Mobile Intel® Celeron® Processor on .13 Micron Process in Micro-FCPGA Package

Specification Update

October 2003

Document Number: 251309-016

Figure 12. System Bus Reset and Configuration Timings

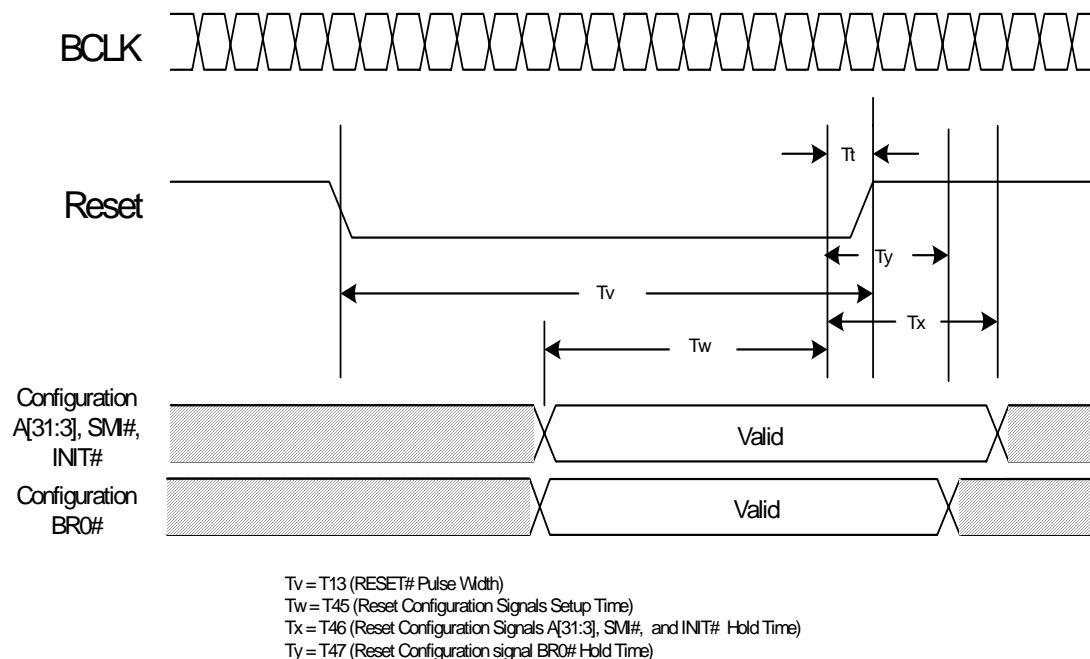
V2. BR0# Maximum Hold Time Specification Change

The BR0# maximum hold time has changed to 2 BCLKs. This change will be shown in the “System Bus AC Specifications (Reset Conditions)” table and “System Bus Reset and Configuration Timings” figure of the *Mobile Intel® Celeron® Processor on .13 Micron Process in Micro-FCPGA Package Datasheet*. This change will be incorporated in the next revision of the datasheet.

The following figure will be modified to reflect this change:

T# Parameter	Min	Max	Unit	Figure	Notes
T45: Reset Configuration Signals (A[31:3]#, BR0# INIT#, SMI#) Setup Time	4		BCLKs	13	1
T46: Reset Configuration Signals (A[31:3]#, INIT#, SMI#) Hold Time	2	20	BCLKs	13	2
T47: Reset Configuration Signal BR0# Hold Time	2	2	BCLKs	13	2
